AMENDMENTS TO THE DRAWINGS

REMARKS/ARGUMENTS

FIG. 1

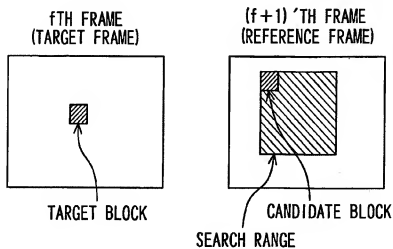
The attached sheet of drawings includes changes to Figures 1-4. The sheets which include Figures 1-4 replace the corresponding original sheets. The legend "PRIOR ART" has been added in each of the figures.
